Staff Report to the Technical Review Committee June 3, 2014

Applicant Kris Stenger Property Location: 1900 and 1906 Curry Ford Rd. (north of Carlton Dr., east of S. Ferncreek Ave., west of Cloverlawn Ave. and south of Curry ford Rd.; PID: 06-23-30-0000-00-068; 06-23-20-30-0002-00-010) (±1.11

Minor Plat request to plat two residential lots

PROPOSED PLAT

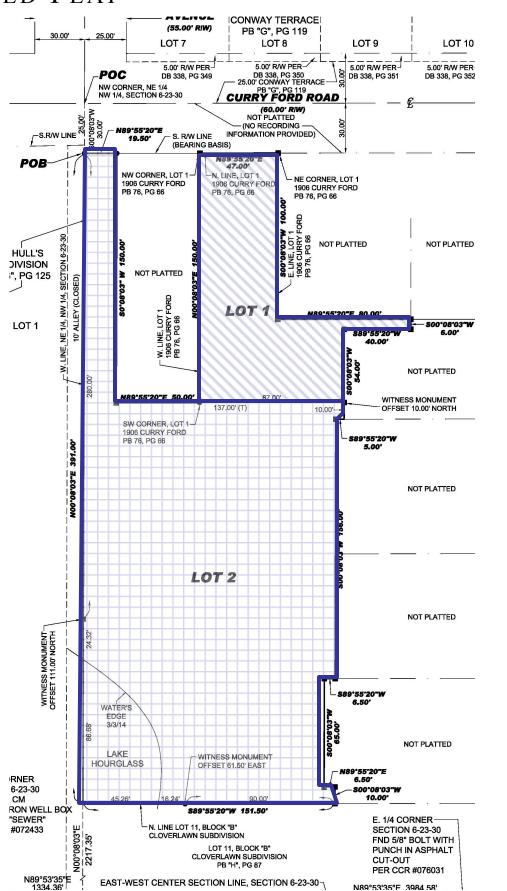
- 7. Plat–Minor. Plat Face Changes There are a number of changes required to the face of the plat. In addition to the changes required on the plat, the following is a list of additional requirements.

- 1) Changes to the face of the plat.
 - 2) Recording Fees (Checks should be made payable City of Orlando.)
 - 3) The plat must be reviewed by Orange County prior to recording. Begin this process by taking a copy of the executed plat to Room 1700 (Orange County Property Appraiser's Office, Attn. Rocco Campanale), 200 S. Orange Avenue, Sun Trust Bank Center. The original completed Statement of Lien from Orange County is required by this office. The Statement of Lien must be received by this office prior to recording the plat.

- 8. Erosion–Building Site. All building site plans submitted for review should include a detailed erosion and sedimentation control plan.
- 9. Storm– Floodplain. Show the 100 year Floodplain on the survey.
